ALERT SERVICE BULLETIN

NO. 206L-01-122

MODEL AFFECTED: 206L-1, 206L-3

SUBJECT: MAGNETIC BRAKE P/N 204-001-376-003 - ONE TIME INSPECTION OF

Figure 1.

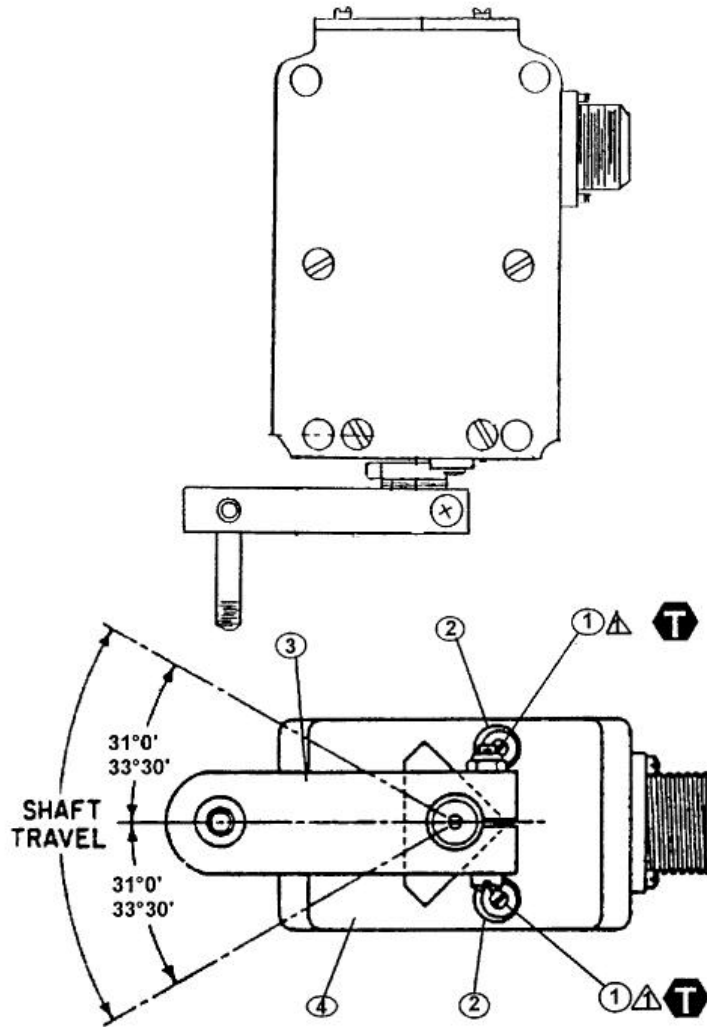
6. Use a torque wrench and screwdriver bit to apply 10 inch/lbs (1.12 Nm) force to screw(s) (1 figure 1) in a counterclockwise direction.
 - a) If screw(s) (1) do not move, go to step 12.

- b) If any movement is found on screw(s) (1), go to step 7.

If the inspection reveals that screw(s) (1) has disengaged, examine arm assembly (4) for mechanical damage created by screw (1). If mechanical damage is found, the depth shall not

exceed 0.030 inch (0.762 mm). Acceptable damage may be smoothed and treated in accordance with the Standard Practice Manual Chapter 3 for Chemical Film. If damage is greater than 0.030 inch (0.762 mm) contact Product Support Engineering.

7. Remove screw(s) (1) and stop limit(s) (2) from magnetic brake (4).
8. Clean residue adhesive from magnetic brake (4) screw holes and screw(s) (1) with compressed air.
9. Apply adhesive (C-320) to screw(s) (1) threads and install in magnetic brake (4) hand tight.
10. Adjust the stop limit(s) (3) to achieve the arm assembly shaft travel, refer to Figure 1.
11. Torque screws (1) 5 to 10 in-lbs (0.56 to 1.12 Nm).
12. Apply torque seal inspection ink to screws (1) and to stop limits (2).
13. Re-install cyclic fore & aft and lateral magnetic brakes into aircraft. Refer to Service Instruction 206-2030; section III, for rigging procedures.
14. Re-install cyclic magnetic brake access panels.
15. Connect battery.
16. Make an entry in the helicopter historical records to show you have completed this Alert Service Bulletin.

-  Bond screw with adhesive C-320
-  5 to 10 IN-LBS
(0.56 TO 1.12 Nm)
